DEVELOPMENT APPLICATION ACCESSIBILITY REPORT

Project Name	Mixed Use Development including 70 residential apartments
Project Address	277 The Grande Parade, Ramsgate NSW 2217
Reference	30061DA
Revision	04
Date	10/07/2026
Attention	Bronxx

Purely Access Pty Ltd has been engaged by Bronxx to provide access consultancy services for the proposed mixed use development at 277 The Grande Parade, Ramsgate NSW 2217.

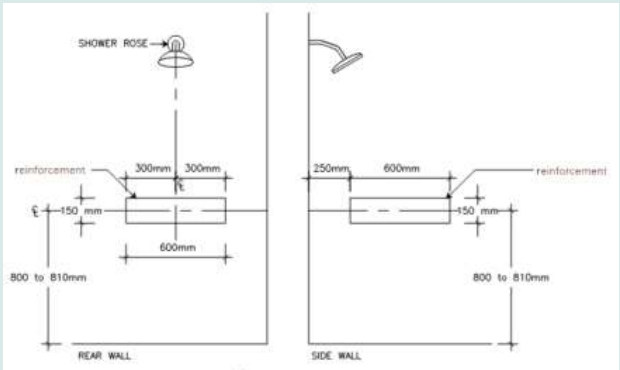
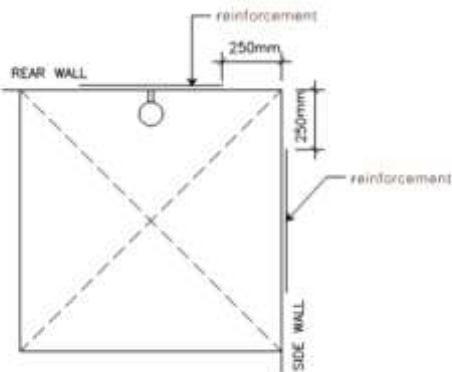
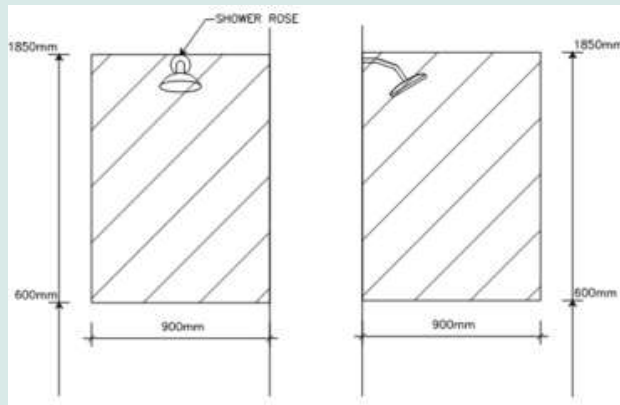
Silver Level Requirement		Comments
1	One bathroom should feature a slip resistant, hobless shower recess. Shower screens are permitted provided they can be easily removed at a later date.	Compliance indicated. Construction Certificate stage to be assessed at the Construction Certificate stage.
2	The shower recess should be located in the corner of the room to enable the installation of grabrails at a future date.	Compliance indicated. Construction Certificate stage to be assessed at the Construction Certificate stage.
Note	For hobless specification please see AS3740-3.6.
